RENESAS TECHNICAL UPDATE

| Product Category | MPU&MCU | Document No. | TN-H8*-A338A/E | Rev. | 1.00 |
| Title | Correction of the H8SX/1600 Series Hardware Manual | Information Category | Technical Notification | | |

2. Interrupt Input Timing

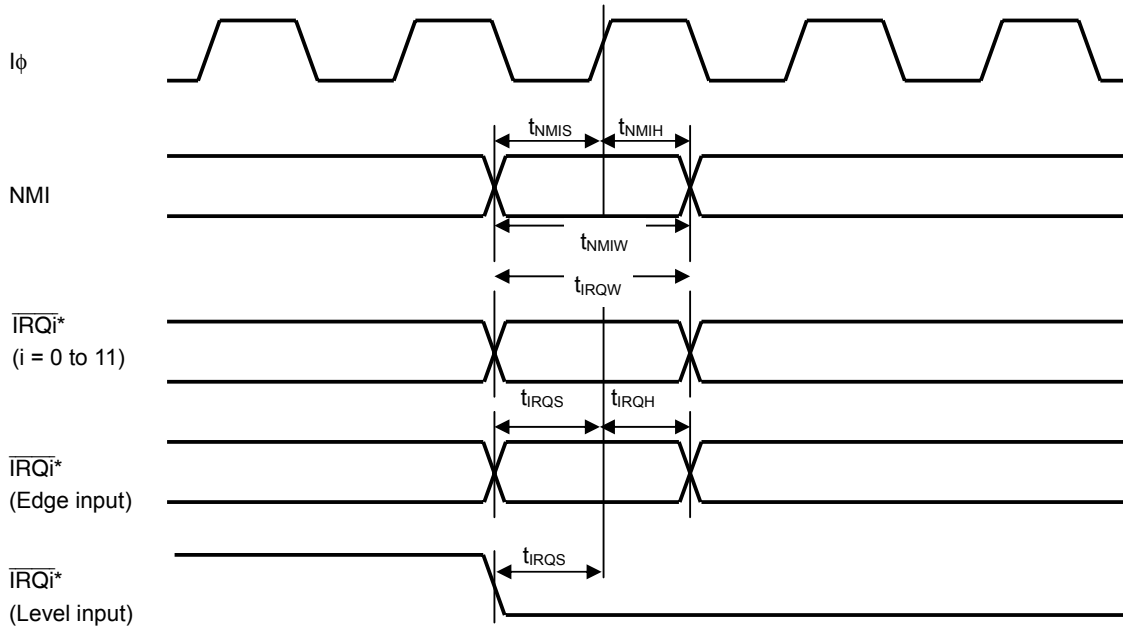
The reference clock in the interrupt input timing figure of electrical characteristics is corrected as follows:

[Before change] Reference clock at $I\phi$ rising

[After change] Reference clock at $I\phi$ falling
